## Chapter 02 District Regulations and Design Guidelines

**EUC PC DISTRICT REGULATIONS**

Mixed-Use Civic/Office Urban Design Diagram (Design Framework Plan)

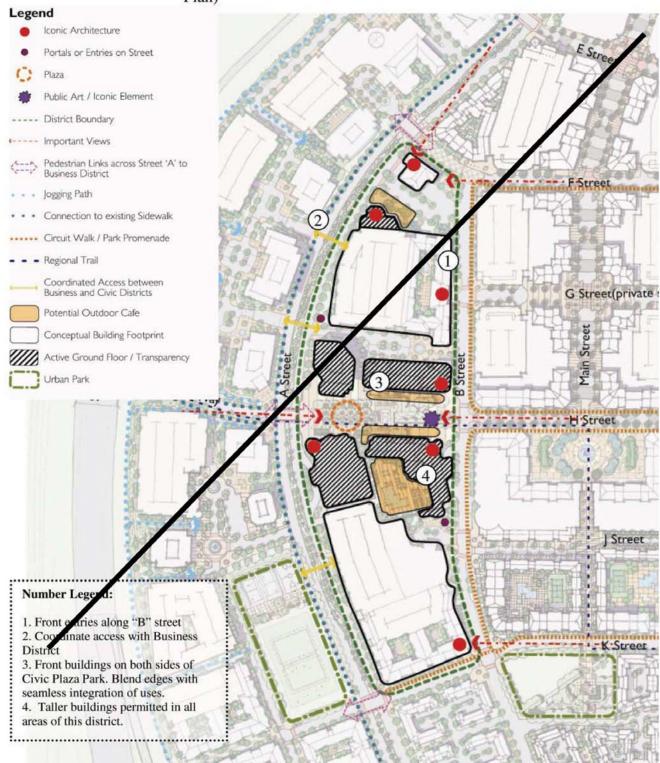
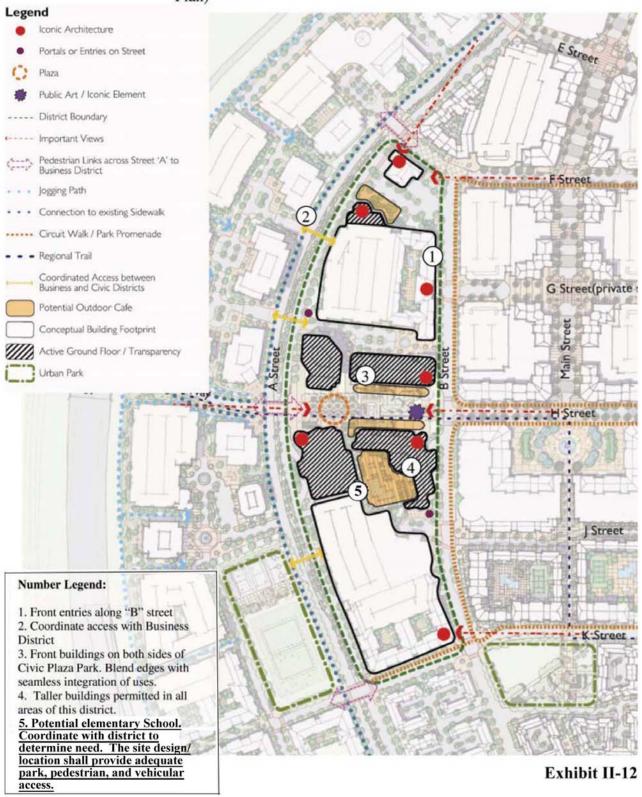
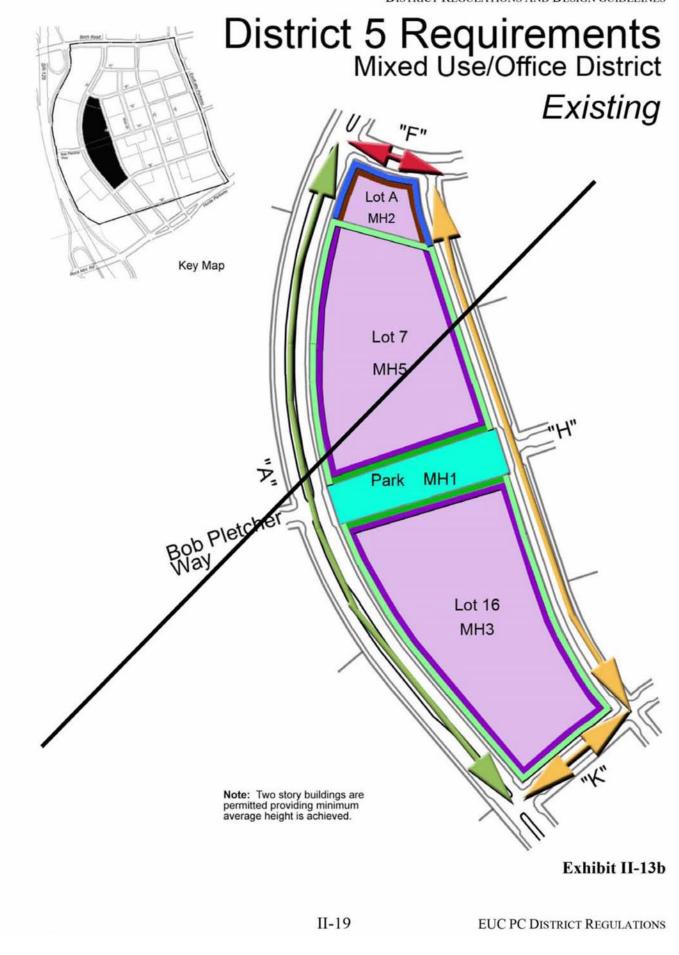
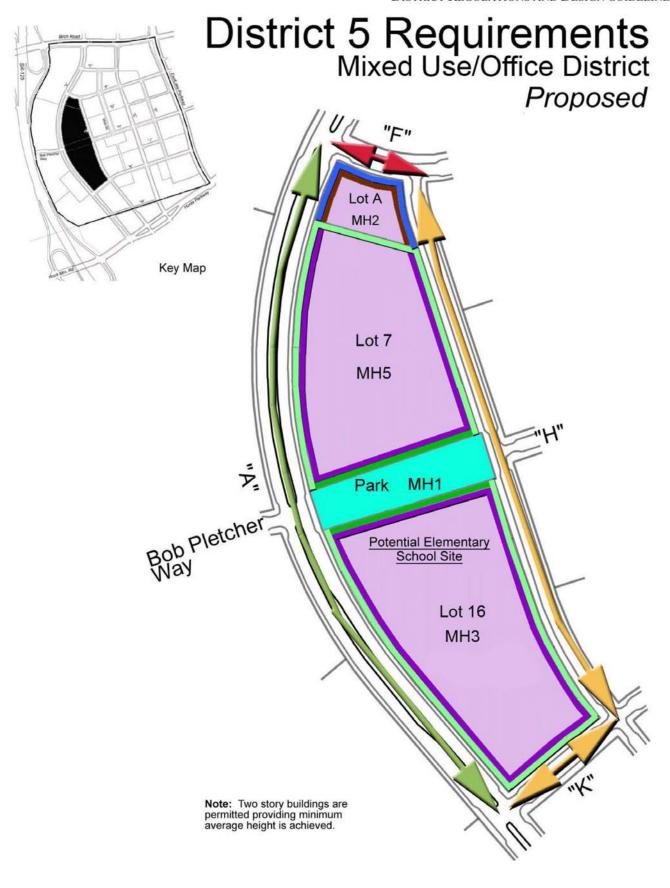
## Existing

## Proposed.

Central Southern Neighborhood District Urban Design Diagram (Design Framework Plan)

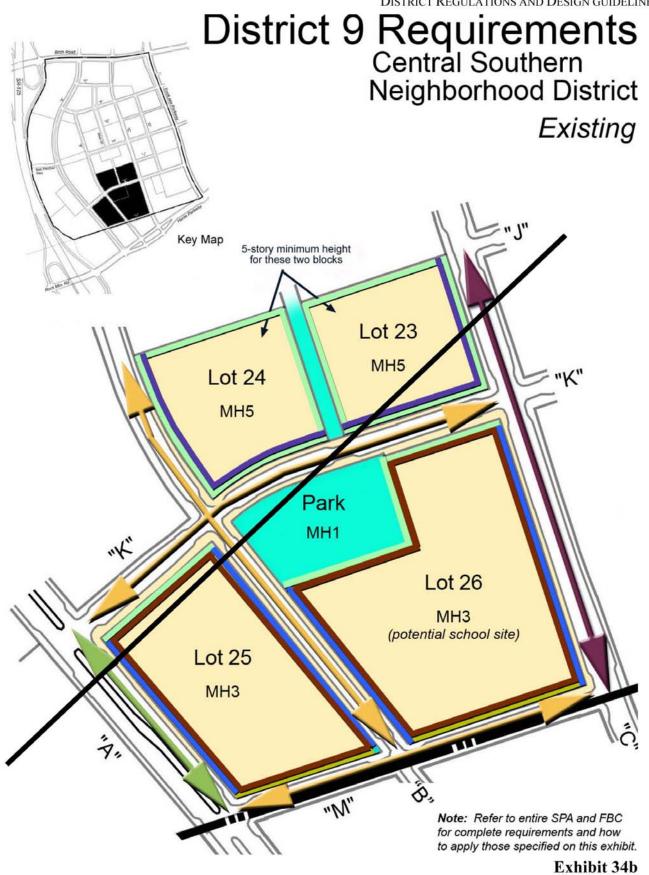
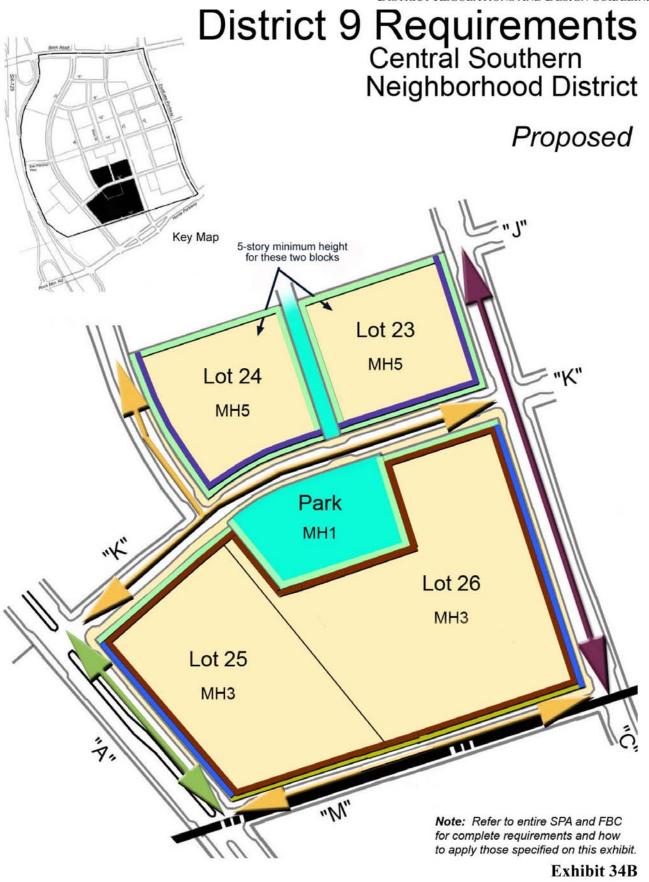
## Proposed

- 1. Extend street grid with streets, drives, or paseos
- 2. Potential Elem. School. Coordinate with district to determine need. The site design/location shall provide adequate pedestrian and vehicular access. School may be in the CS District as an alternative location to be determined by the school district. Park and school should develop strong connections.
- 3. Transit Guideway with limited access b/w parcels to the north and south. Widen setback for safety if pedestrian corridor is adjacent to Transit Guideway.
- 4. Create urban character along edge, but front doors are not required to front on Transit Guideway.
